SAFETY EVALUATION REPORT

**Docket No. 71-9337
Model No. 3979A
Certificate of Compliance No. 9337
Revision No. 0**

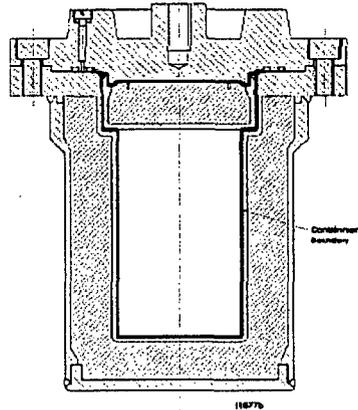
Comment [M6]: RAI 3-15
Remove the temperature limit of 204C from Table 3-3 for the containment vessel lid seal and replace it with the batch test temperature of 200C from Chapter 8. Also, the Note 1 associated with this seal temperature limit should reference the batch testing requirements for this seal.
10CFR71.35 requires (a) a demonstration that the package satisfies the standards specified in subparts E and F.
